**STAFF REPORT
FOR THE CITY COUNCIL**

FILE NUMBER: AP-20-03

REQUEST: Appeal by Jason and Jessica Harra of a Planning Commission decision to approve the 2-year extension of a previously approved 34-lot subdivision at 18000 Upper Midhill Drive (MISC-20-04)

Figure 810.2.2 Dimensions of Bus Boarding and Alighting Areas

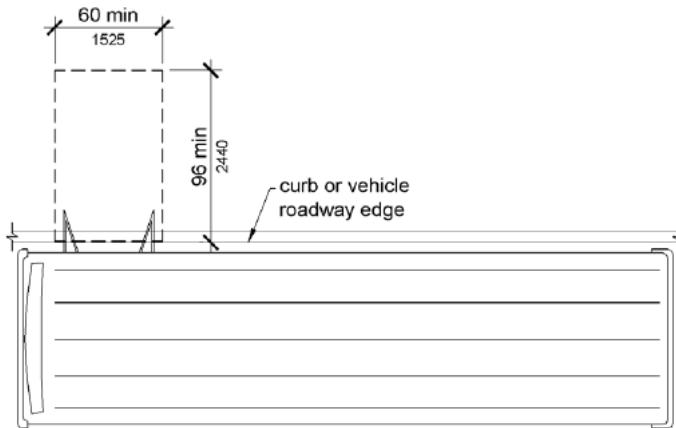
On the southeast corner of the intersection, at the location of a Tri-Met bus stop, pedestrians, bikes and transit users will all share a space just 5 ½ feet if the proposed improvement is constructed.

The Department of Transportation ADA Standards for Transportation Facilities (2006) requires an eight foot by five foot area in location of bus boarding or alighting as shown below in Figure 810.2.2 from ADA¹. These dimensions currently exist at the location of the two bus stops, but would not exist near the location of the southeast corner bus stop if the interim improvements are constructed. ADA 810.2.2 states “Bus stop boarding and alighting areas shall provide a clear length of 96 inches (2440 mm) minimum, measured perpendicular to the curb or vehicle roadway edge, and a clear width of 60 inches (1525 mm) minimum, measured parallel to the vehicle roadway.”

In addition to the lack of area to continue to meet ADA requirements, pedestrians, cyclists, transit users will all need to share a much more narrow space than currently exists and which does not meet standard in order to accommodate the impacts of this proposed development. As there is no identified funding for the ultimate Highway 43 improvement, this situation could exist for many years if the interim improvements are approved for construction.

Chart 1: AADT – Willamette Drive (2016-2018)

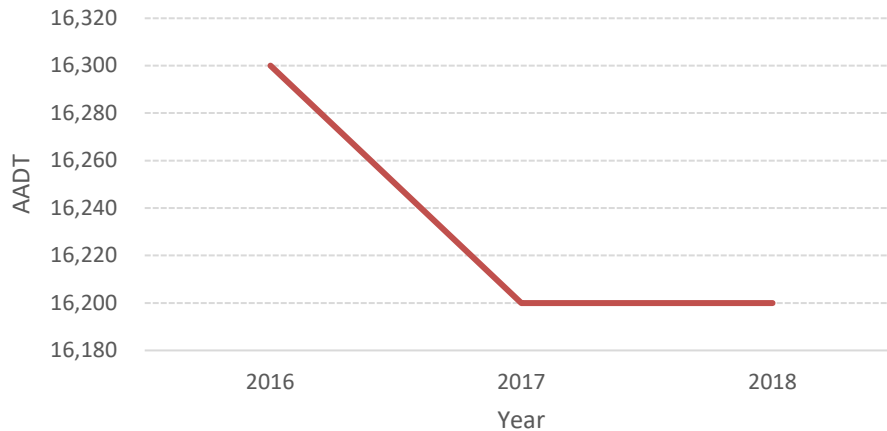
Traffic volumes along Willamette Drive near Arbor Drive have remained relatively flat over the last several years. ODOT's transportation volume tables provide average annual daily traffic (AADT) volumes for points along all state highways, including Willamette Drive. Chart 1 displays the three most recent years of data available (2016-2018) at a point located approximately 0.03 miles north of Arbor Drive. As shown, AADT along Willamette Drive was the same in 2018 as it was in 2017 and lower than it was in 2016. Therefore, there have been no material changes in traffic volumes along Willamette Drive near Arbor Drive since approval of the development application.

Chart 2: Crash History – Willamette Drive/Arbor Drive Intersection (2016-2018)

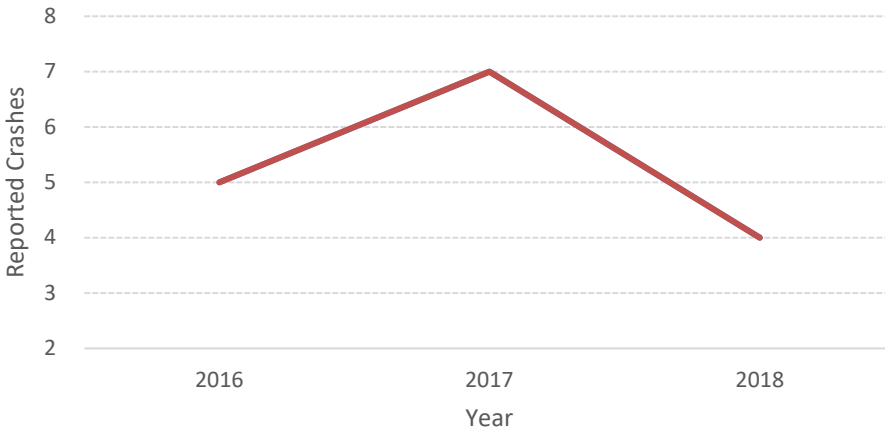
The total number of reported crashes at the Willamette Drive/Arbor Drive intersection have remained relatively flat over the last several years. ODOT maintains a database of reported crash for all state highways and local roadways, including Willamette Drive and Arbor Drive. Chart 2 displays the three most recent years of crash data available (2016-2018) for the Willamette Drive/Arbor Drive intersection. As shown, the total number of crashes was lower in 2018 than it was in 2017 and in 2016. It should also be noted that of the 16 crashes reported at the intersection over the three-year period, none of the crashes resulted in a fatality or serious injury. Therefore, there have been no material changes in crash history at the Willamette Drive/Arbor Drive intersection based on the available crash data.
